# Access Compliance Report

## Public Rights-of-Way

Intersection ID: 50709	Main Street: ARRIVAL_DR	Cross Street: BROTHERLY_LN	Location: SE
ADA ID: 2A88D1CA322D	Ramp Type: PerpDiag	Initial Pass/Fail: Pass	Overall Compliance: No
Severity Score: 10.25			
Codes/Mitigation Info/Possible Solution		Field Measurements/Component Compliance

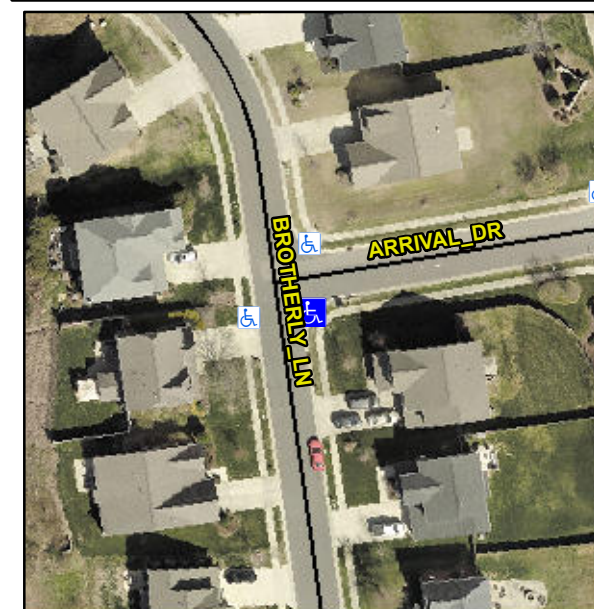
**R304.5.3, R304.2.1, R304.2.2-Perp, R304.3.2-Para**

Compliance	Description	Data	Compliance	Description	Data
N/A	Ramp Length (in)	94.5	Yes	Ramp Slope (%)	6.7
Yes	Ramp Width (in)	48.0	No	Ramp XSlope (%)	2.6
N/A	Flare Type LT	Sloped	N/A	Flare Type RT	N/A
N/A	Flare Slope LT (%)	3.6	Yes	Flare Slope RT (%)	7.0
N/A	Flare Traversable LT?	Yes	N/A	Flare Traversable RT?	Yes
No	Landing Length (in)	N/A	Yes	DWS Provided?	Yes
No	Landing Width (in)	N/A	Yes	DWS Contrast?	Yes
No	Landing Slope (%)	N/A	Yes	DWS Length (in)	24.8
No	Landing X Slope (%)	N/A	Yes	DWS Full Width?	Yes
N/A	Landing Curb? (Y/N)	No	Yes	DWS Offset (in)	1.5
N/A	Shared Landing?	No			
Yes	Gutter Ponding?	No	Yes	Gutter Slope (%)	4.7
Yes	Gutter Lip Ht (in)	0.0	No	Gutter X Slope (%)	3.0
N/A	Painted X Walk1?	No	N/A	Painted X Walk2?	No
	X Walk 1 Direction	To N		X Walk 2 Direction	To W
N/A	X Walk 1 Width (in)	N/A	N/A	X Walk 2 Width (in)	N/A
	X Walk 1 Slope (%)	2.8		X Walk 2 Slope (%)	0.1
	X Walk 1 X Slope (%)	1.1		X Walk 2 X Slope (%)	3.0

**Remove & Replace Curb Ramp With Two New Directional Ramps or Equivalent. Remove & Replace Gutter.**
